ADDENDUM NUMBER SEVEN

RFQ # 7449435

TITLE: RENOVATIONS TO THE ART CENTER AT RI COLLEGE

**Art Center Renovation – Rhode Island College
600 Mount Pleasant Avenue
Providence, Rhode Island**

**PHASING PLAN &
CONSTRUCTION
PHASING SCHEDULE**

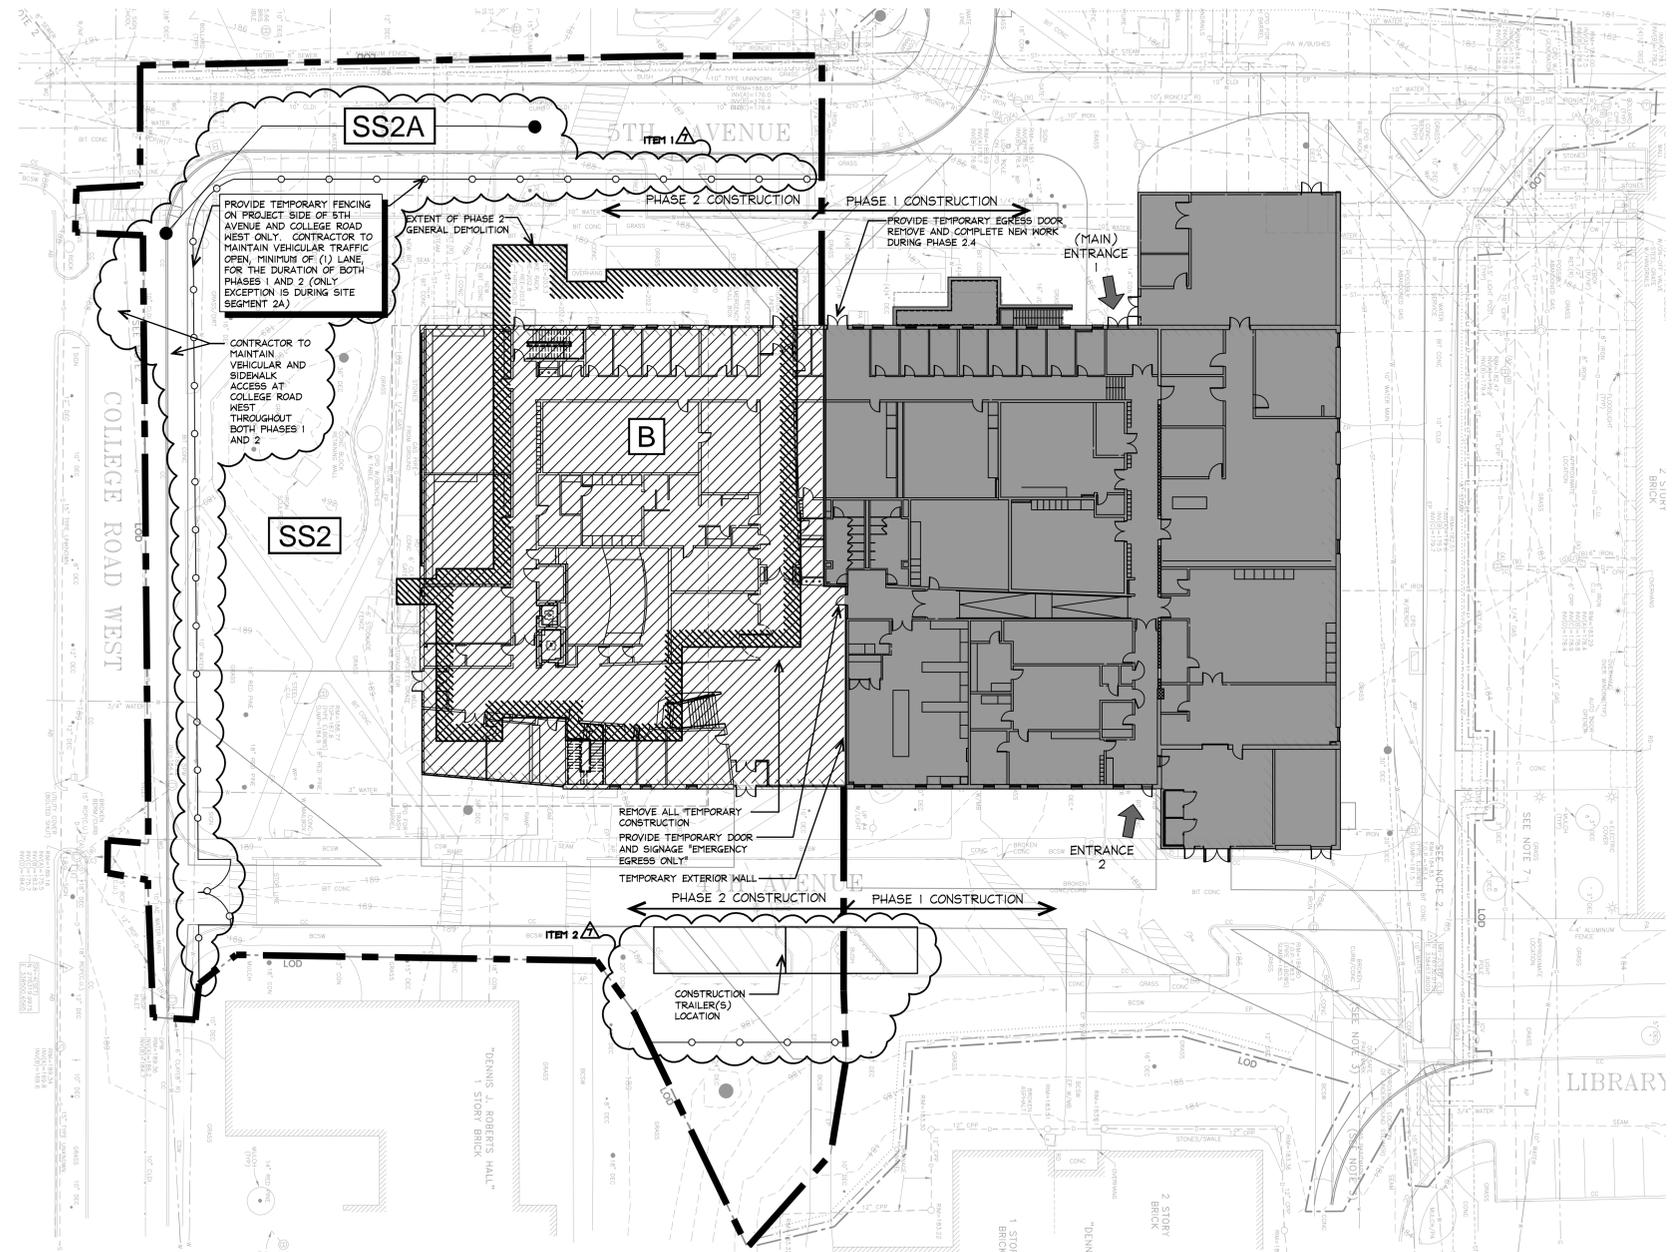
- ITEM 1:** At Drawing #1 Phasing 1, along east side of building along existing 4th Avenue, add construction trailer location(s), add temporary fencing for temporary site and contractor entrances, and change location of building temporary entrance on east side of the building. **See revised drawing sheet PH1.1 this Addenda.**

- ITEM 2:** At Drawing #1 Phasing 1, at bottom of drawing, add general note for contractor parking. **See revised drawing sheet PH1.1 this Addenda.**
- ITEM 3:** At Drawing #1 Phasing 1, at bottom of drawing, add general note for staging areas. **See revised drawing sheet PH1.1 this Addenda.**

- ITEM 4:** At Drawing #1 Phasing 1, along west side of building along existing 5th Avenue, add temporary fencing and note for contractor to maintain vehicular traffic on 5th avenue. **See revised drawing sheet PH1.1 this Addenda.**

PH1.2

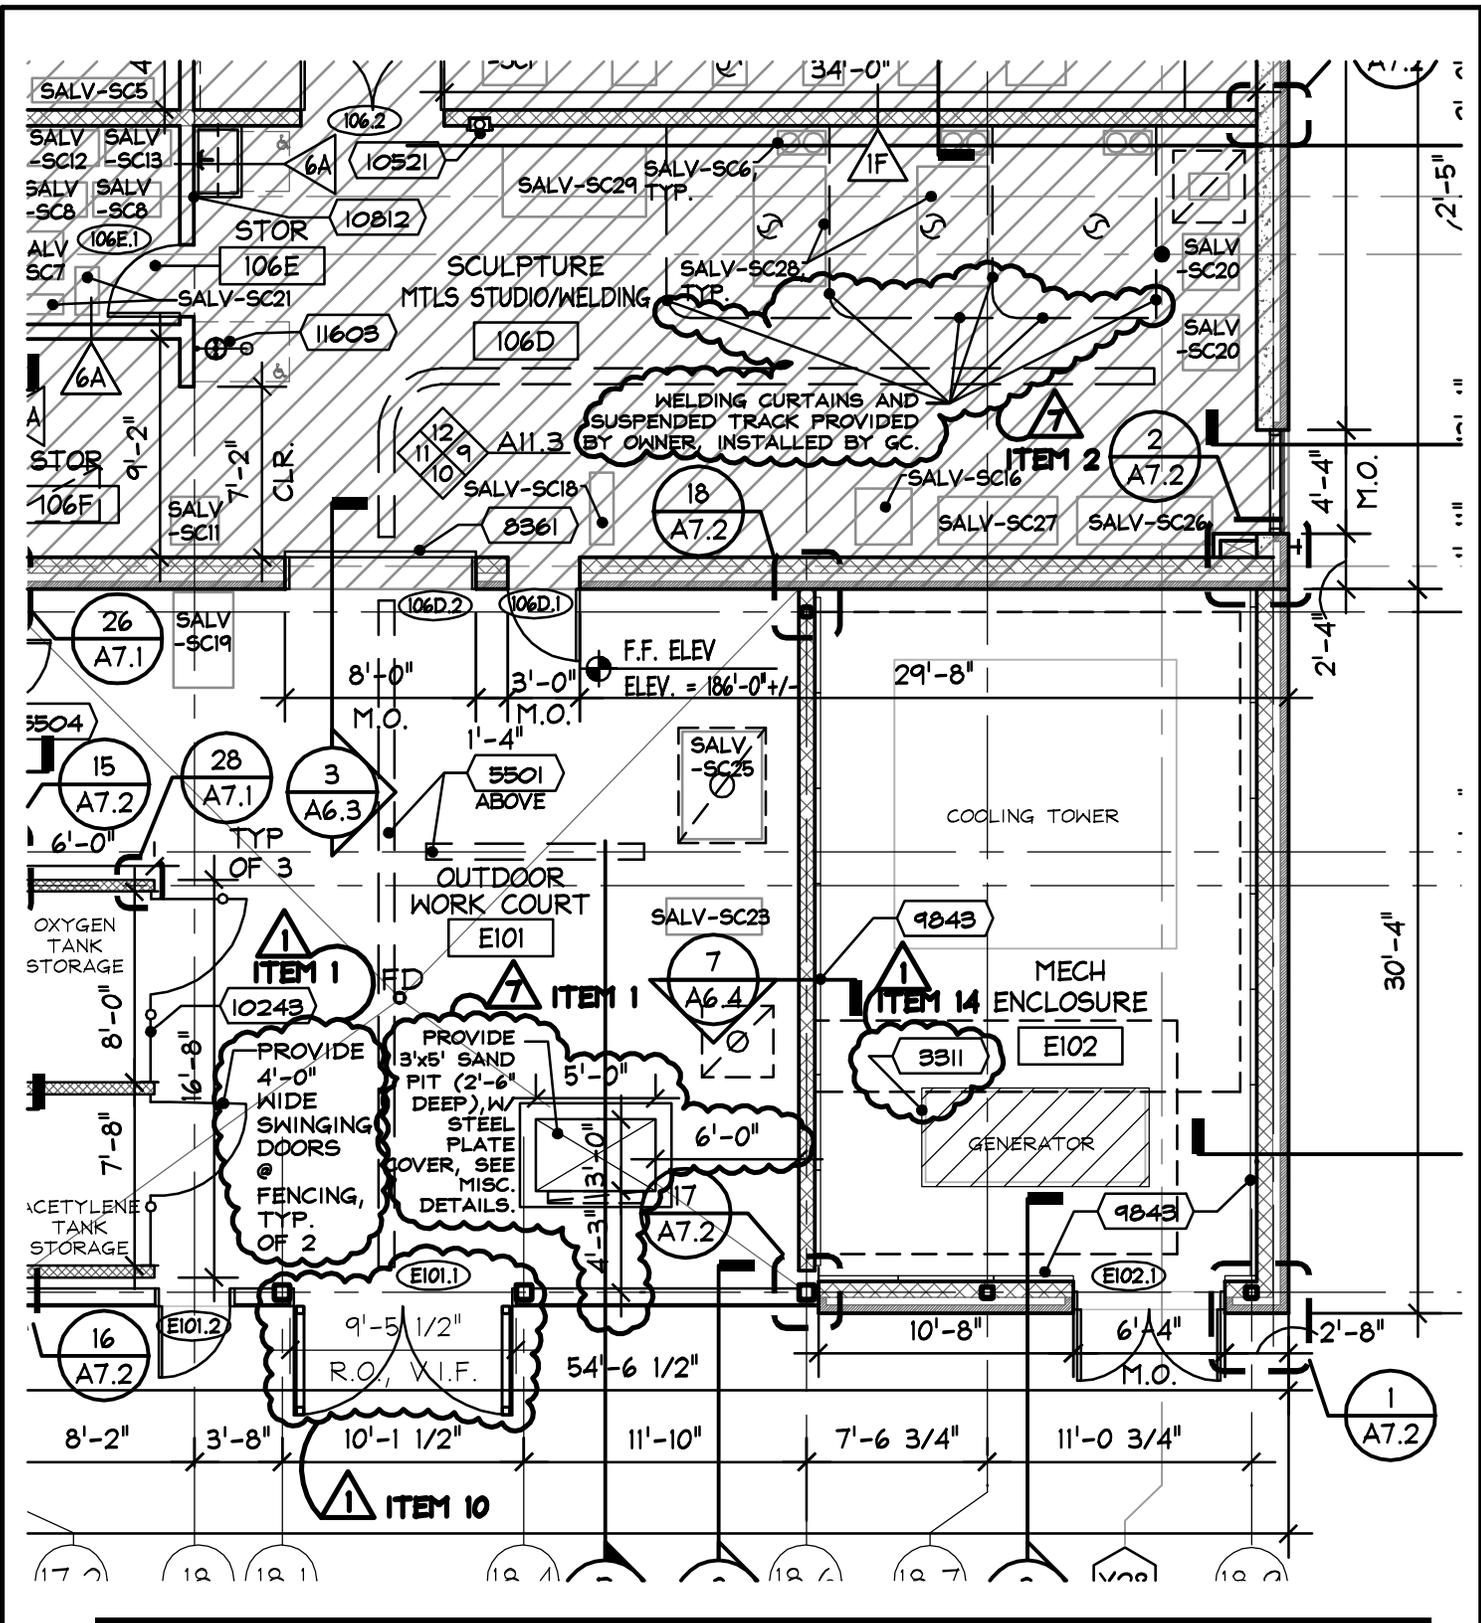
- ITEM 1:** At Drawing #1 Phasing 1, along west side of building along existing 5th Avenue, AND SOUTH SIDE OF BUILDING AT sidewalk of College Road West, add note for Site Segment 2A (SS2A). Also, add temporary fencing and notes for contractor to maintain vehicular traffic and sidewalk access at these locations. **See revised drawing sheet PH1.2 this Addenda.**
- ITEM 2:** At Drawing #1 Phasing 1, along east side of building along existing 4th Avenue, add construction trailer location(s).. **See revised drawing sheet PH1.2 this Addenda.**

REVISION TO DRAWING A1.2

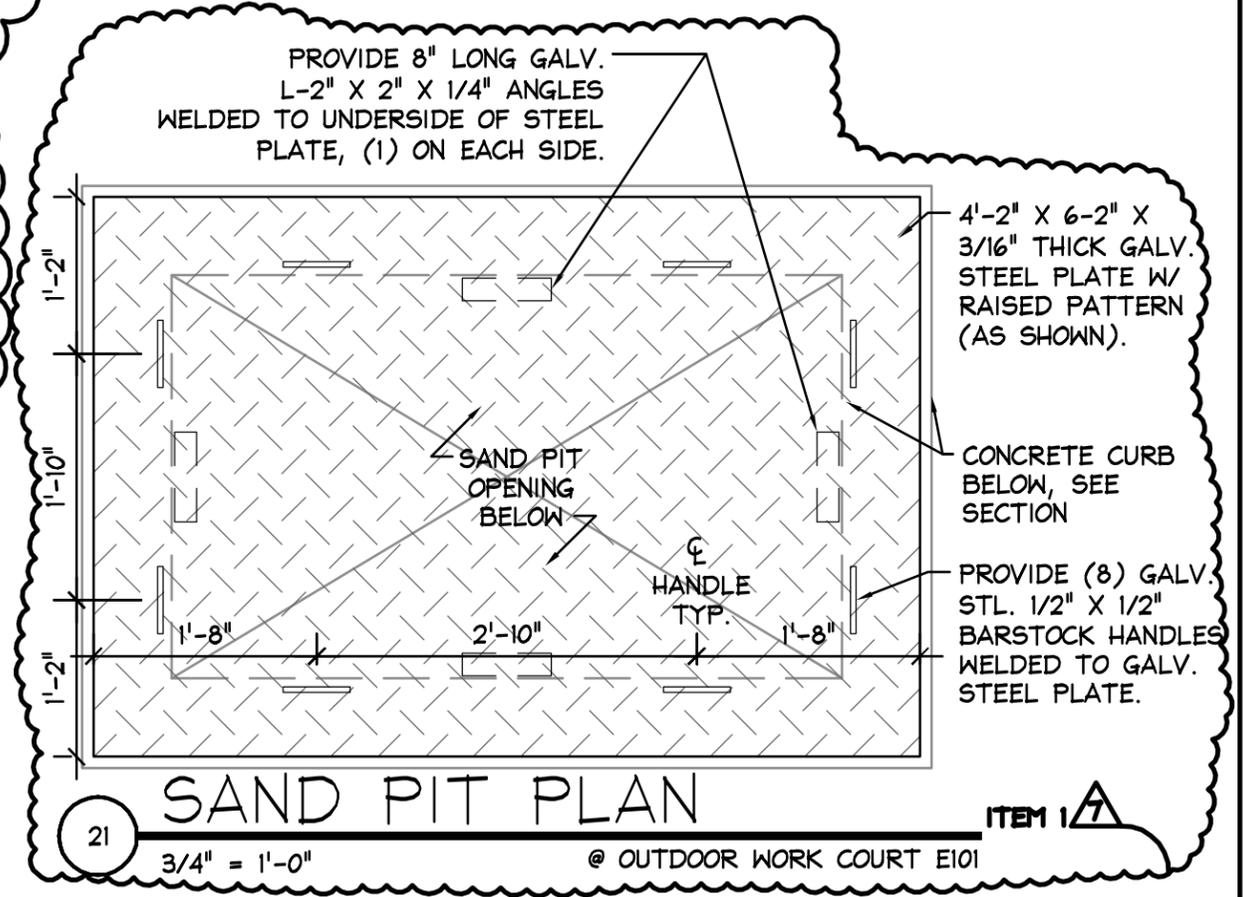
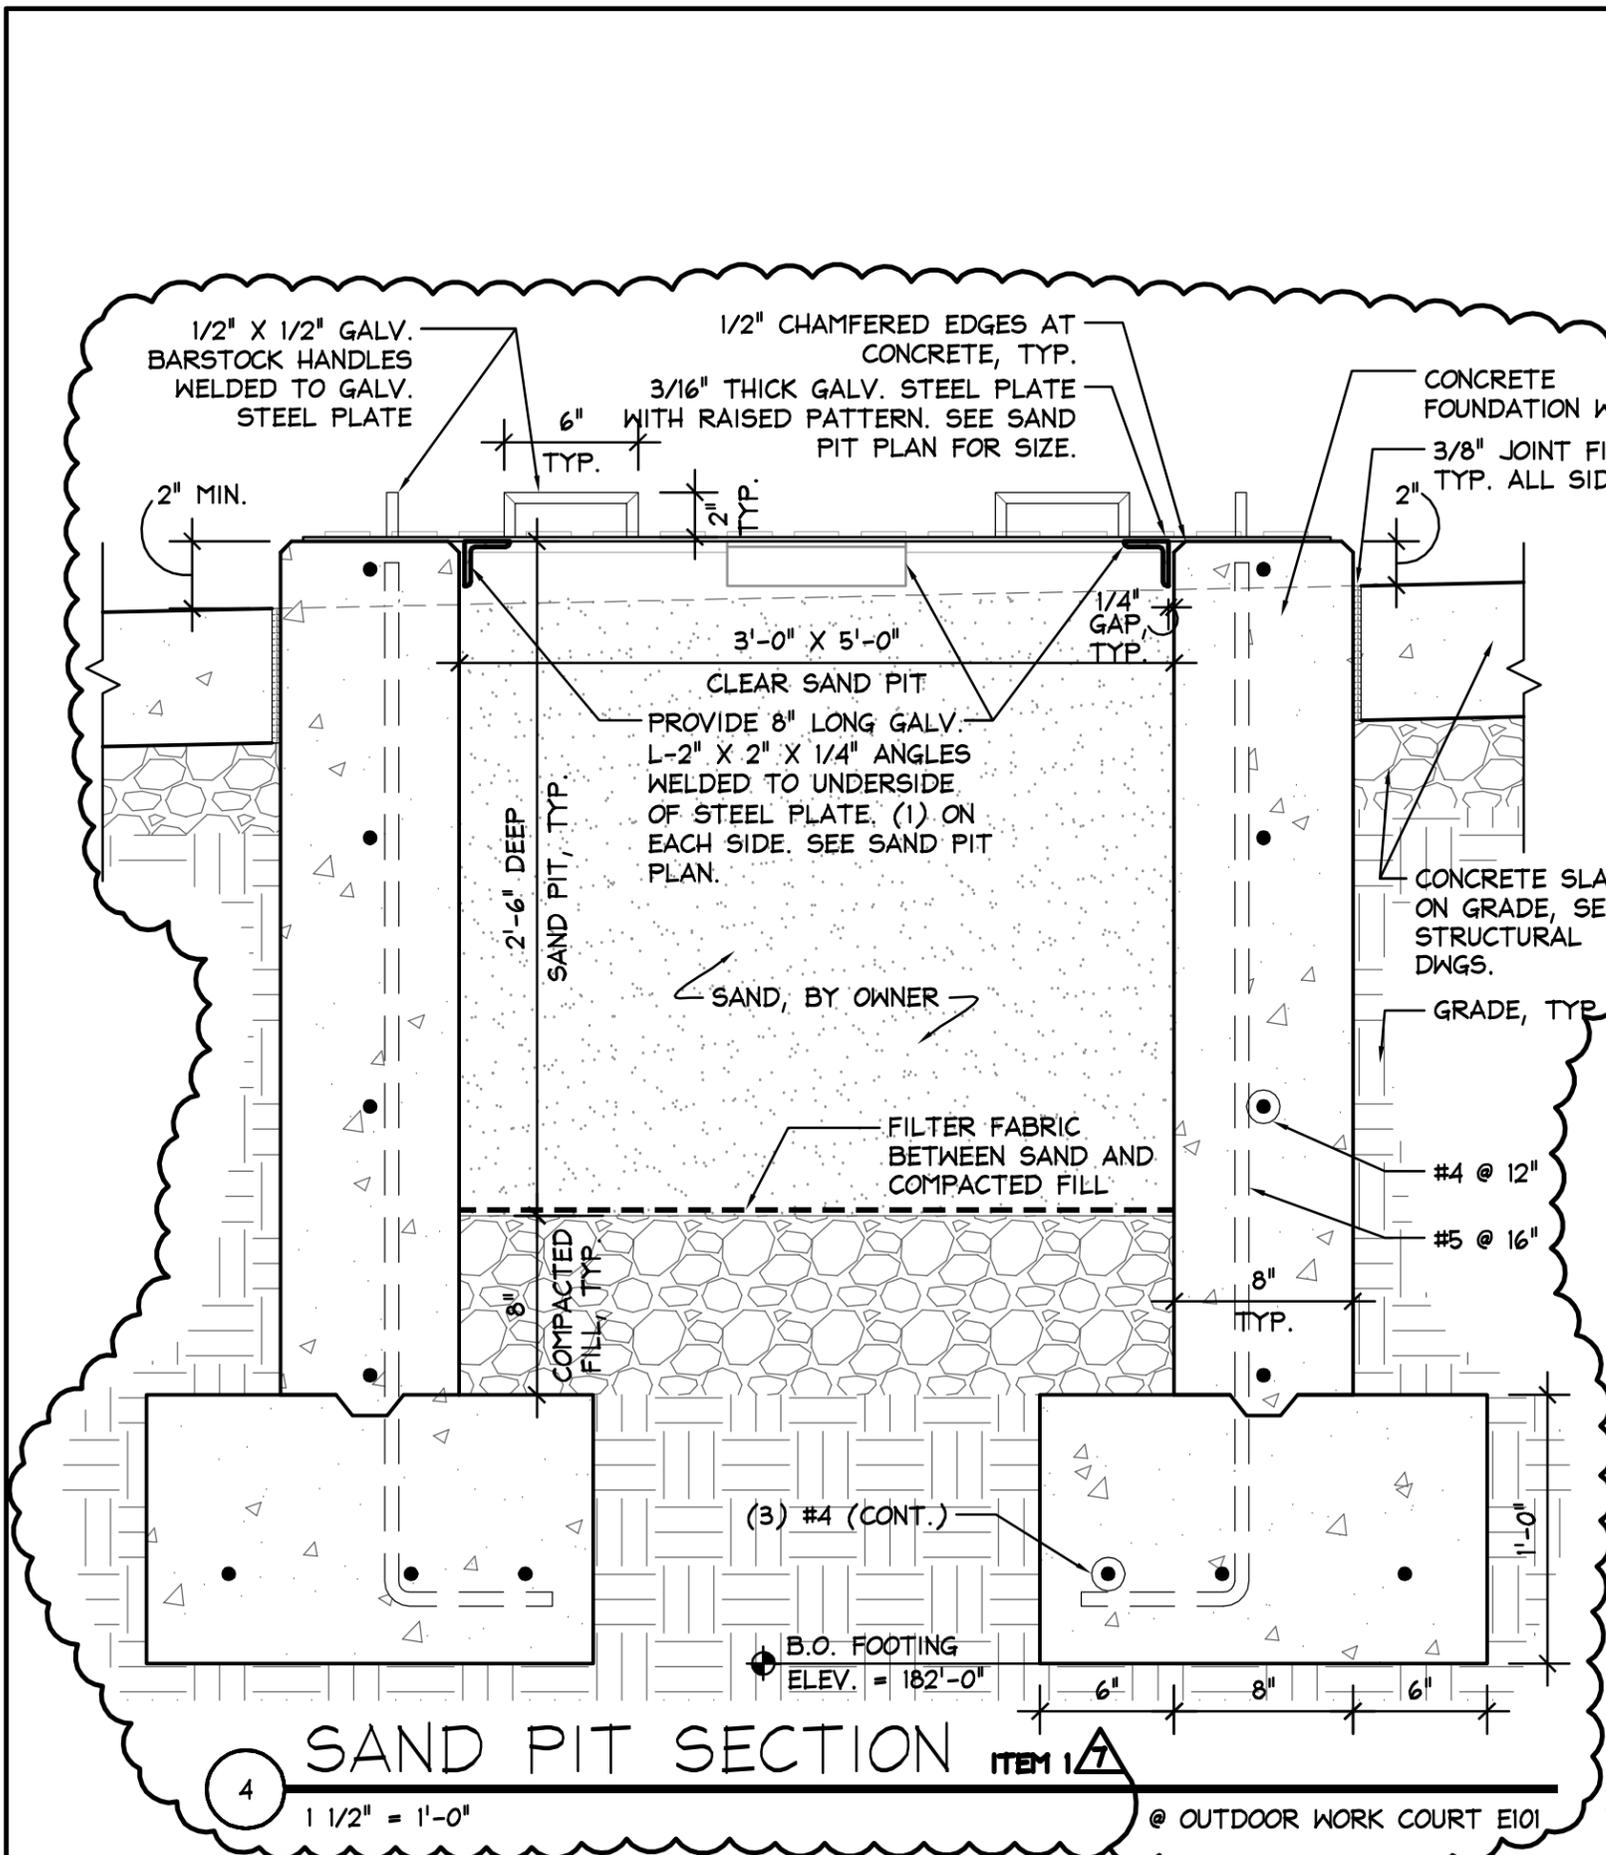
- ITEM 1:** At Drawing #1 First Floor Plan, in lower right corner of plan, at Outdoor Work Court E101, add sand pit with steel plate cover. See SKA-A-087.
- ITEM 2:** At Drawing #1 First Floor Plan, in lower right corner of plan, at room 106D Sculpture Metals Studio/ Welding, add note to dashed lines above welding area “WELDING CURTAINS AND SUSPENDED TRACK PROVIDED BY OWNER, INSTALLED BY GC.” See SKA-A-087.
- ITEM 3:** In top center of drawing sheet, add general note that reads as follows:
“GENERAL NOTE: GC SHALL COORDINATE INSTALLATION BY OTHERS OF OWNER FURNISHED ITEMS, INCLUDING FURNITURE, FIXTURES, EQUIPMENT, KILNS AND AUDIO/ VISUAL TECHNOLOGY.”
